STATE BUILDING CODE TECHNICAL REVIEW BOARD

Friday, May 21, 2021 - 10:00am (Virtual Meeting)

49
50 Appeal of Monica and Michael Davis; Appeal No. 20-03:
51
52 After review and consideration of the final order presented in the
53 Review Board members' agenda package, Mr. Payne moved to approve
54 the final order with the suggested editorial change to delete "d" for the
55 word "required", creating the word "require", in line 100 on page 37
56 and remove the word "do" and replace it with the word "may" in line
57 157 of page 43 of the agenda package. The motion was seconded by
58 Ms. Jackson and passed with Messrs. Pharr, Givens, Hutchins, and
59 Mays abstaining.

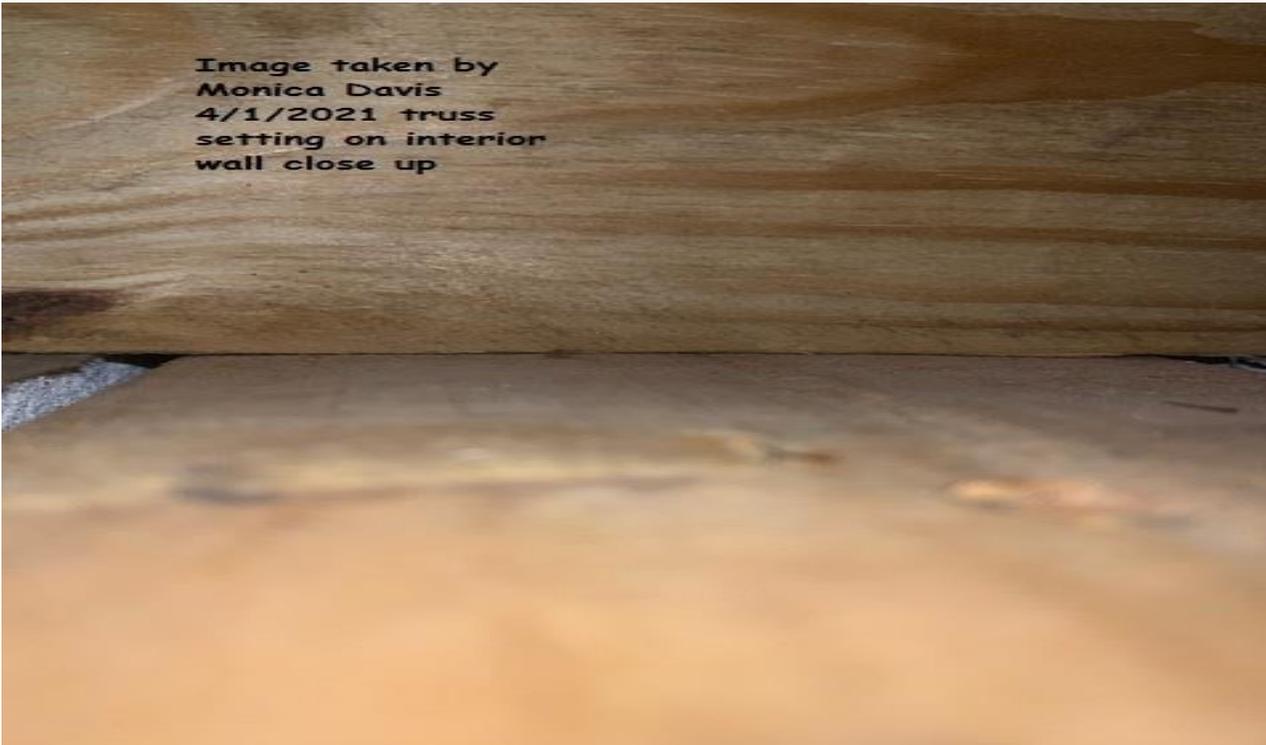
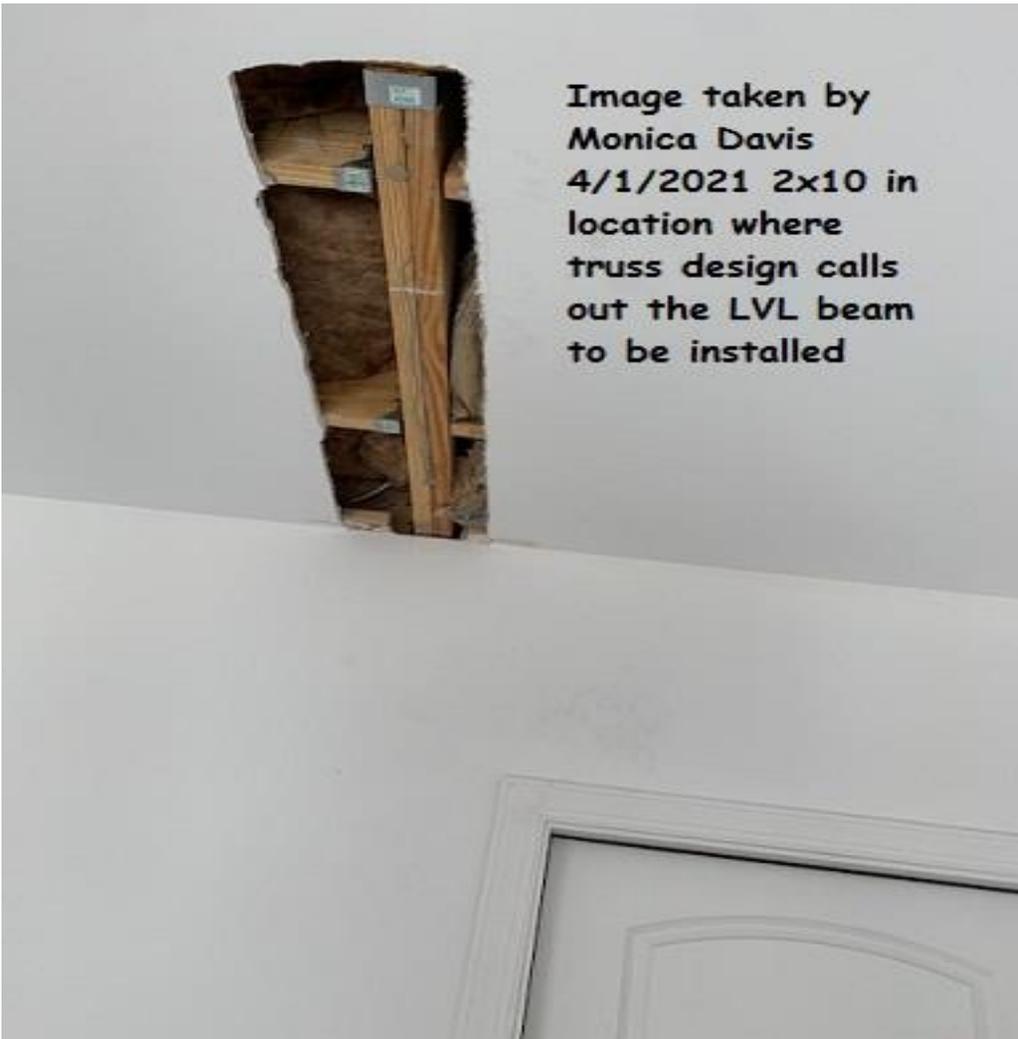
Image taken by
Monica Davis
4/1/2021 another
truss onthe wall

Image taken by Monica Davis
4/1/2021 image shows truss in
hanger with 1 1/2 nails here 3 inch
screws belong and gap in hanger is a
quarter of an inc
